ADDENDUM NO. 3

BROOKSIDE ELEMENTARY SCHOOL – BUILDING B
DSA NO. 03-113415

OAK PARK UNIFIED SCHOOL DISTRICT

AB
12

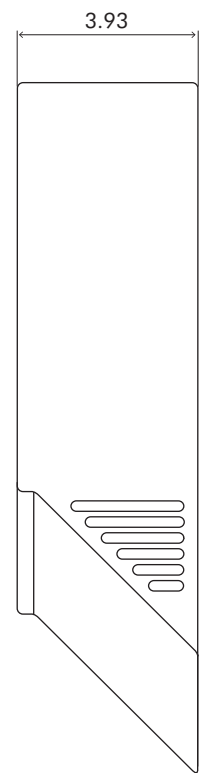
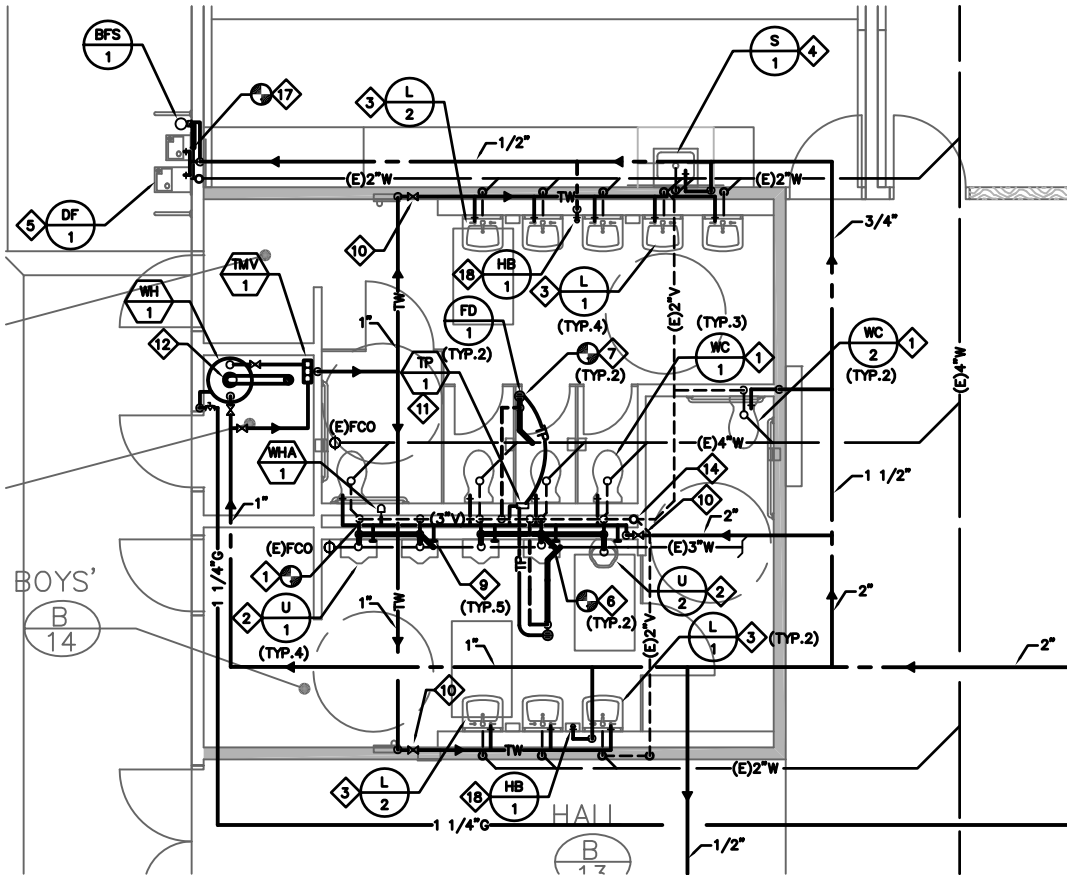
- J. Electric Hand Dryer: Dyson Airblade V No. AB12 sprayed nickel finish, surface-mounted. Unit shall extend a maximum of 3-7/8" from wall finish to comply with ADA requirements. District-Furnished, Contractor-Installed. Refer to the attached Product Data Sheet, 2 pages.
